DESIGN HISTORY

Access and Handhole Covers

**ACCESS COVER AND HANDHOLE COVER
(AFTER SEPTEMBER 2001)**

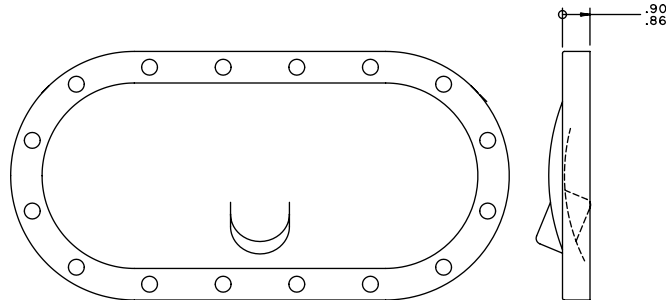
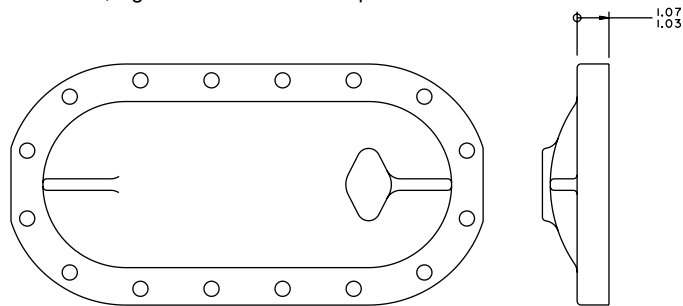
P Compressors, Styles A and B, were produced with the access and handhole covers machined from two different castings through September 2001. The flange thickness of the access cover is greater than that of the handhole covers and requires longer screws.

Beginning in October 2001, P Compressors use only access covers. Handhole covers will no longer be produced and should not, under any circumstances, be used to service P compressors produced after September 2001.

The access cover flange is nominally .17 inch (.13 - .21 inch) thicker than the handhole cover flange. The screw used with the access cover is nominally .25 inch (.19 - .31 inch) longer than the screw used with the handhole cover. The shorter screw, previously specified for use with the handhole cover, may not have adequate thread engagement if used with the access cover. The longer screw, specified for use with the access cover, may “bottom out” in the threaded hole tapped for the shorter screw. Make certain all of the sixteen (16) longer screws, securing an access cover replacing a handhole cover, do NOT “BOTTOM OUT”. Increase the depth of the threaded hole by manually tapping additional threads if necessary. Failure to observe this precaution may result in gasket leaks.

HANDHOLE COVER THROUGH SEPTEMBER 2001		
ITEM	DESCRIPTION	PART NO.
207	HANDHOLE COVER	064-21645-000
35	SCREW, HEX FLANGE, .4375-14 X 1.75	021-17692-000

Item numbers correspond to those specified in SECTION 3 – RENEWAL PARTS, Figure 47 and Table 2. Torque Item 35 to 78 – 90 lb.-ft.

ITEM	DESCRIPTION	PART NO.
25	ACCESS COVER	064-48176-000
27	SCREW, HEX FLANGE, .4375-14 X 2.00	021-17693-000

Item numbers correspond to those specified in SECTION 3 – RENEWAL PARTS, Figure 47 and Table 2. Torque Item 27 to 78 – 90 lb.-ft.
